SUBJECT: CANTERWOOD (TTM No. 37439) TRAFFIC IMPACT ANALYSIS RESPONSE TO COMMENTS

The following Response to Comments letter has been prepared for the proposed Canterwood (TTM No. 37439) development ("Project"), which is located on the northeast corner of Leon Road and Craig Road in the County of Riverside, to address the comments prepared by the City of Menifee, dated March 23, 2020. The City on Menifee comments are provided in Attachment A of this letter.

ATTACHMENT A
CITY OF MENIFEE COMMENTS, MARCH 23, 2020

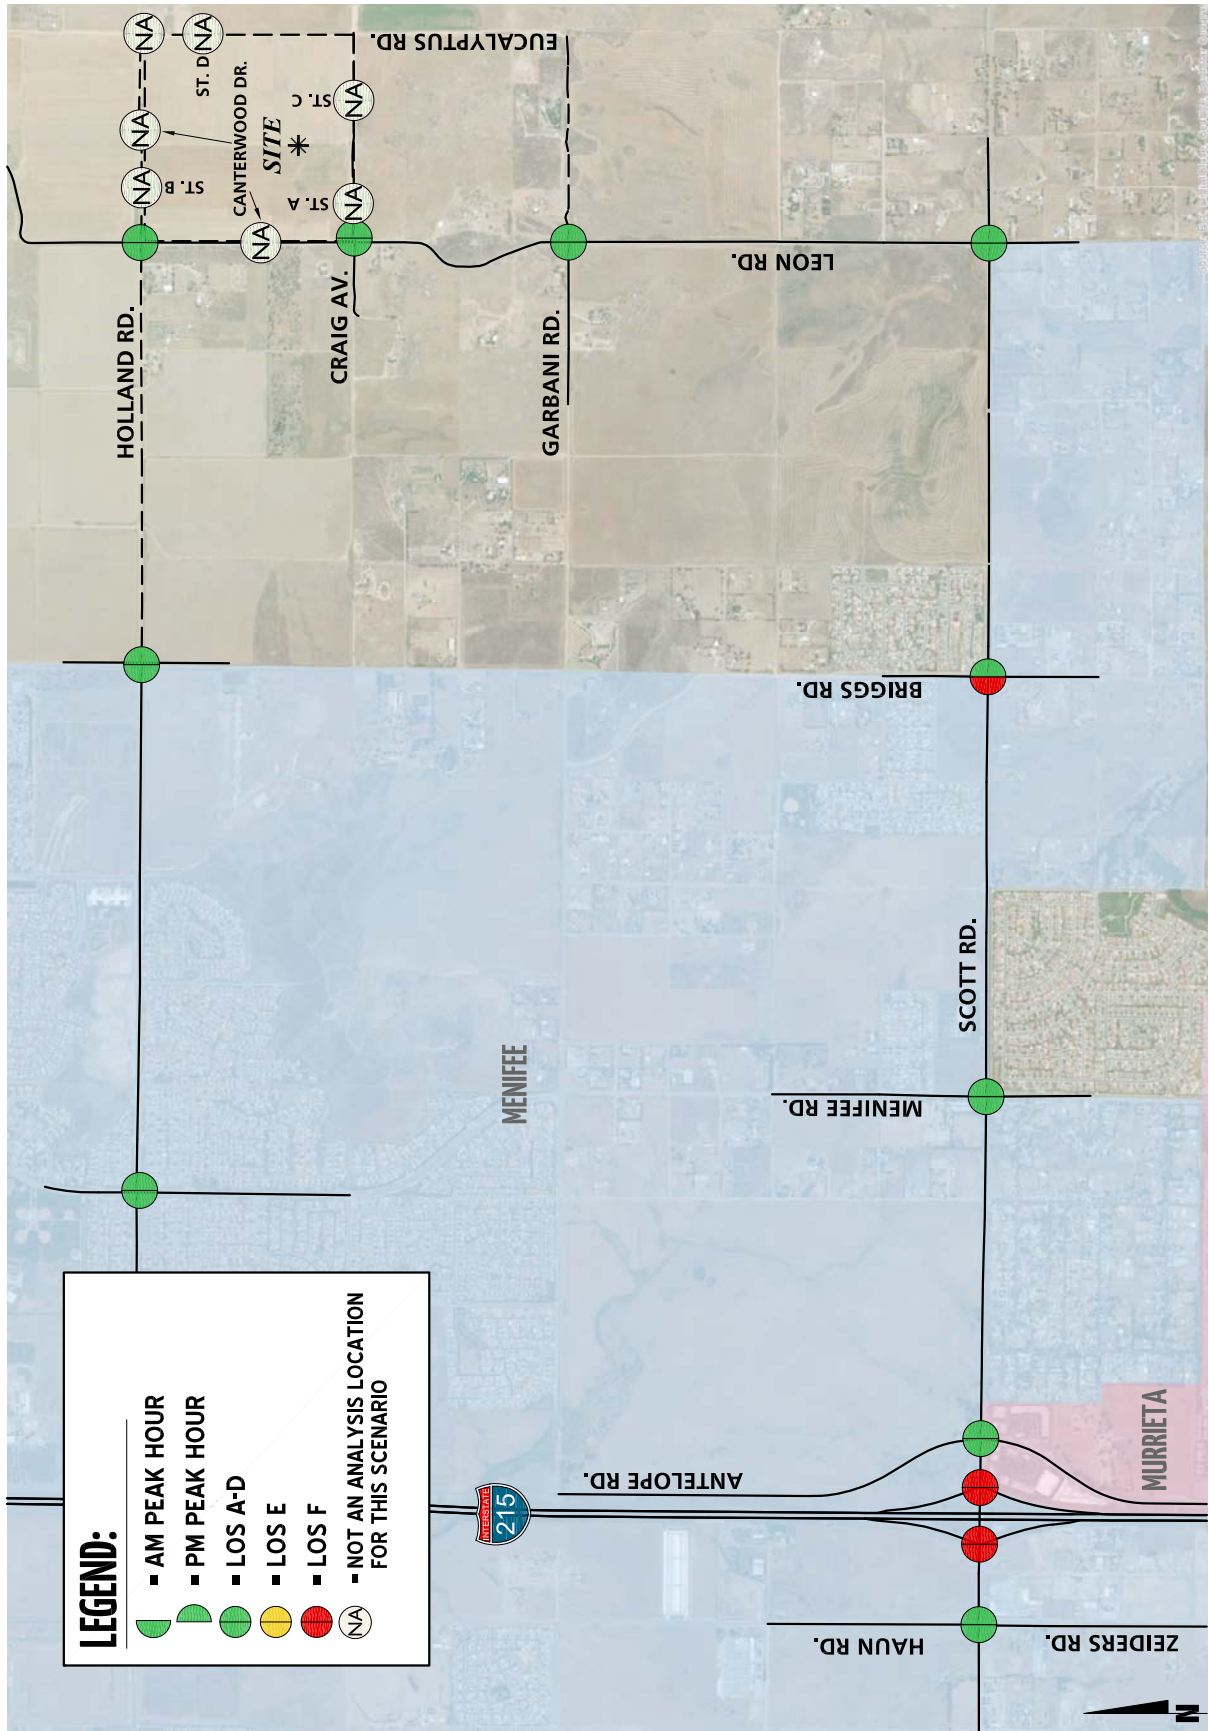
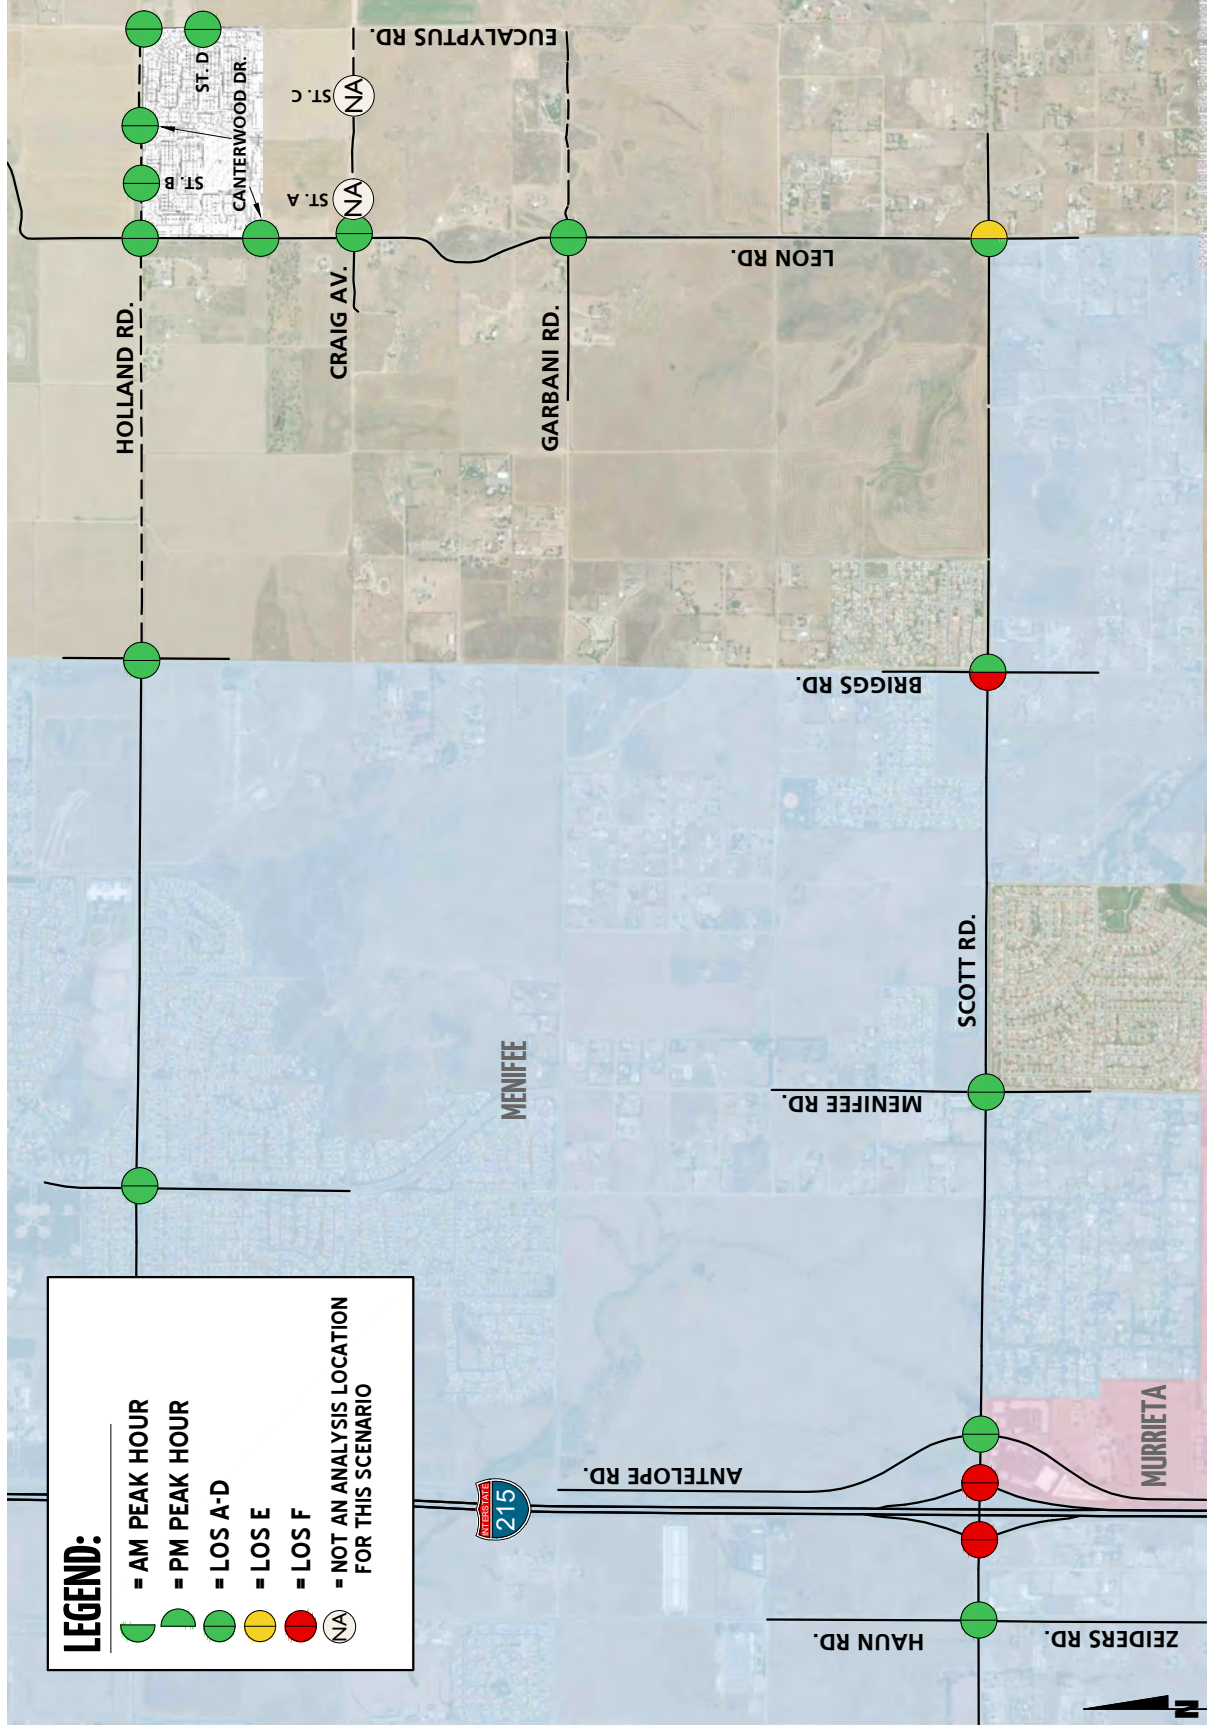
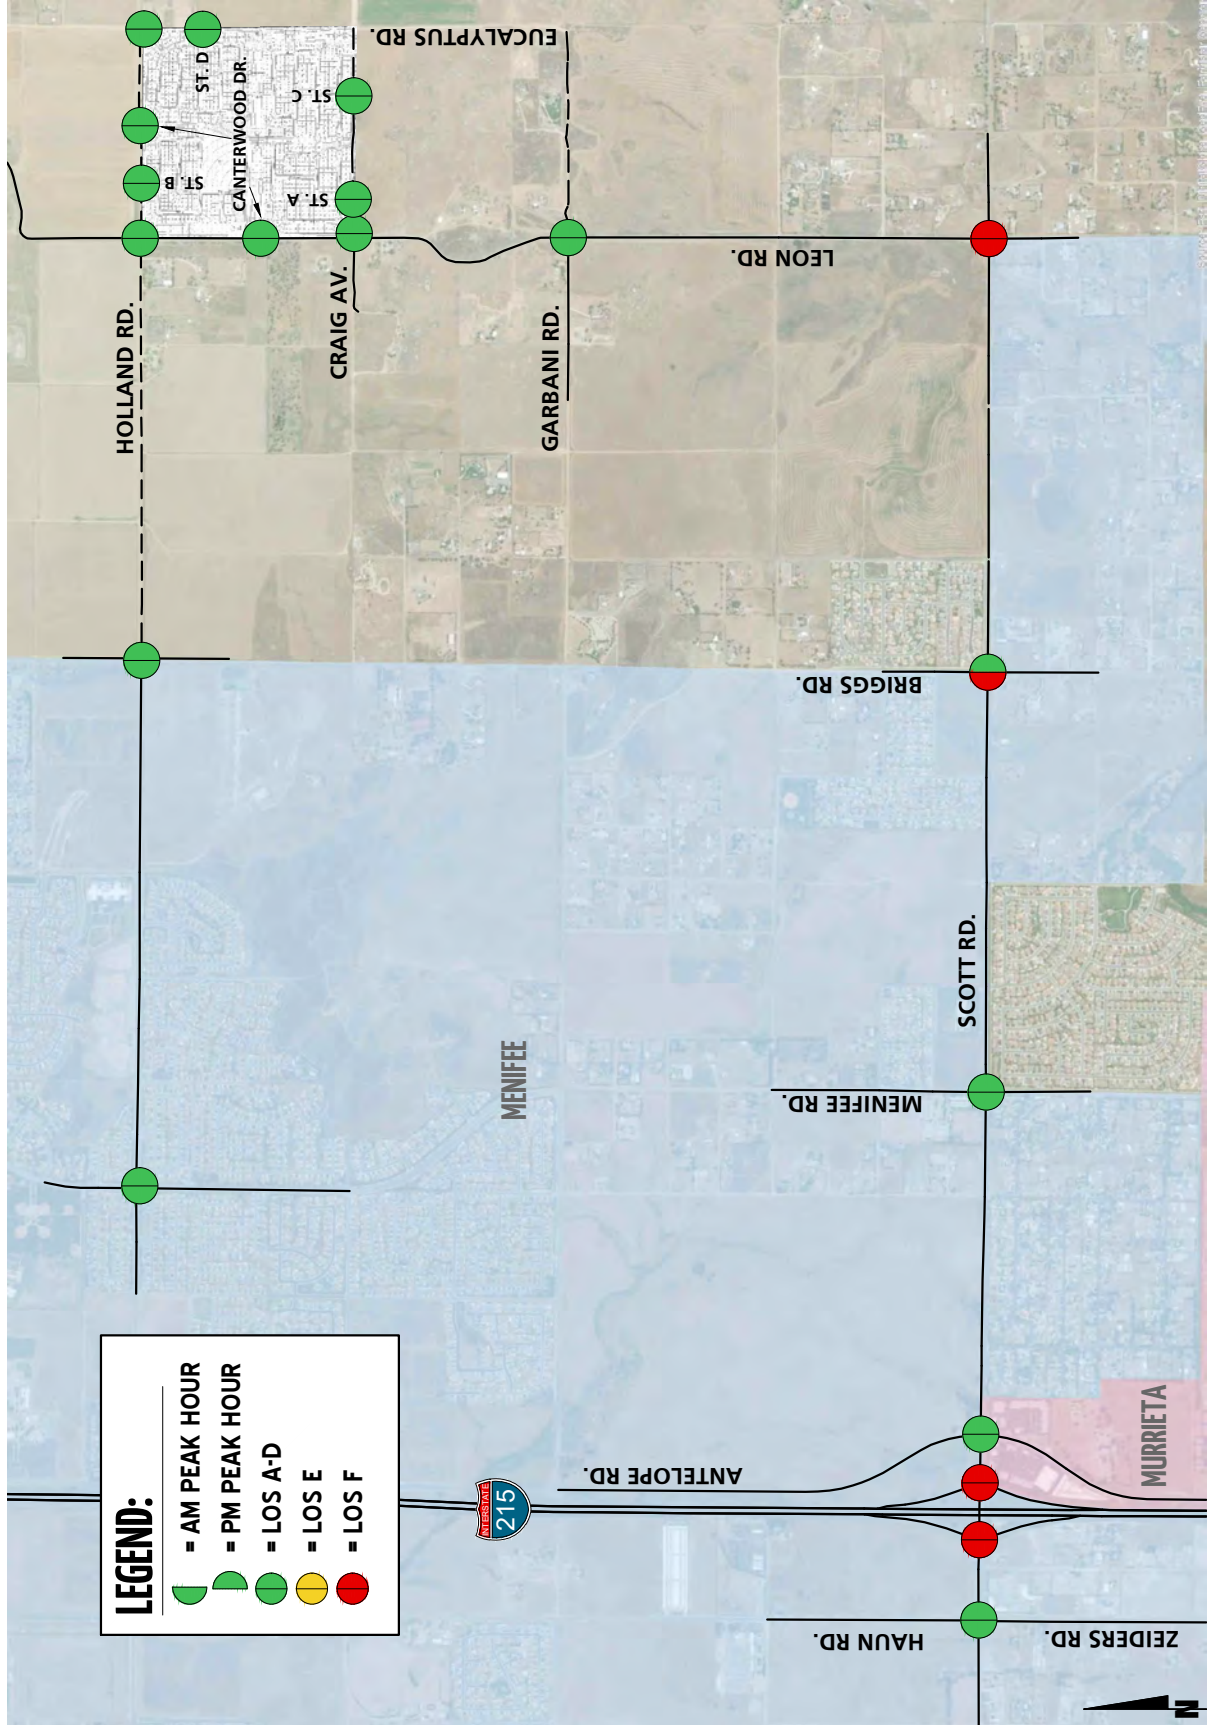
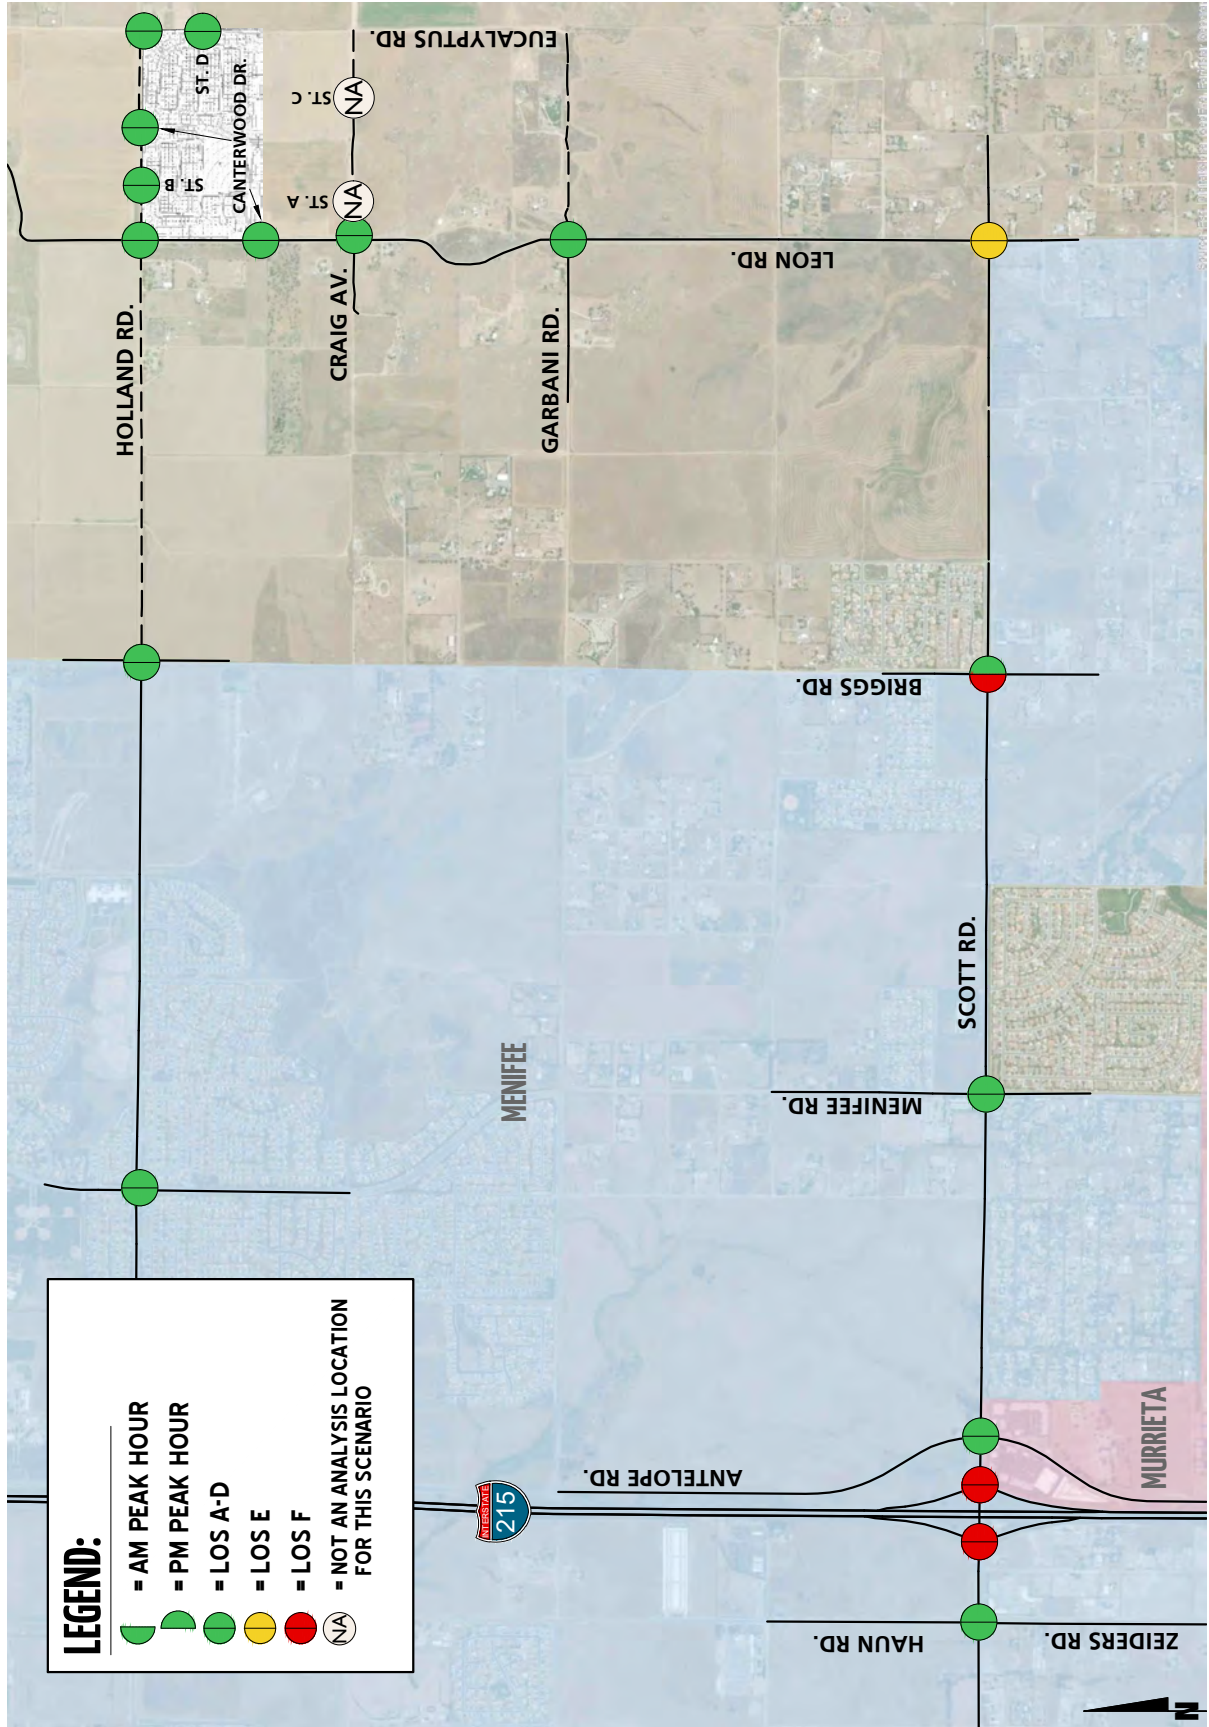
4. Summary of LOS Exhibit (all scenarios): On some of the exhibits for some intersections, the condition shown on the exhibit is not consistent with what is reported in the intersection conditions table. For example, on Exhibit 6-6 for Scott Rd/Leon Rd, the PM condition is shown as green, but should be red. Please check all the exhibits to match the intersection conditions table.

All summary of LOS exhibits has been reviewed and updated to be consistent with the intersection LOS tables. The typo occurs on the LOS summary of exhibits only. However, the intersection improvement recommendations are based on the intersection analysis tables not the exhibits, therefore no findings would change in the Traffic Study. The corrections to the affected summary of LOS exhibits are attached to this response to comments letter.
